KEYSTONE ELECTRONICS CORP.			
www.keyelco.com • NEW HYDE PARK, NY 11040 • Tel (516) 328-7500			
PART NAME			
PC BATTERY HOLDER (3) 'AA' W/ RIBBON			
MATERIAL			
AS NOTED			
FINISH		DRN BY	DATE
NICKEL PLATE		BOONE	12.01.03
		APP'D	SCALE
		LN	1X
TOLERANCES	INCH [MM]	CODE	DWG NO.
DECIMAL	± .015 [± 0.38]	C	2464RB
ANGULAR	± 1°		
UNLESS OTHERWISE SPECIFIED

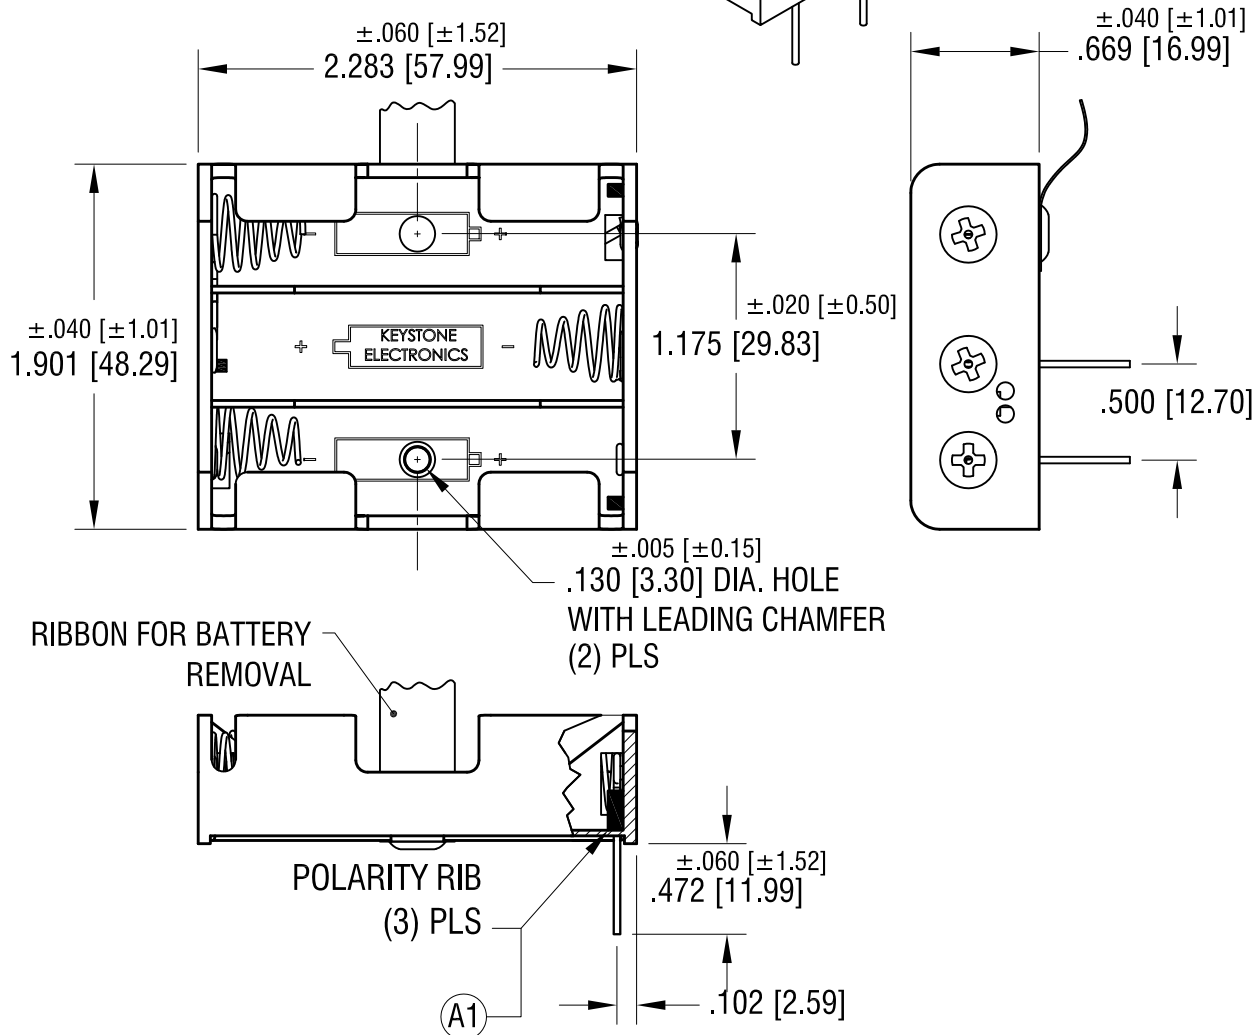
2.08.22	SHOW POLARITY STOPPER (A1) CHANGE AS PER ECN 22-033	A
DATE	DESCRIPTION	REV.
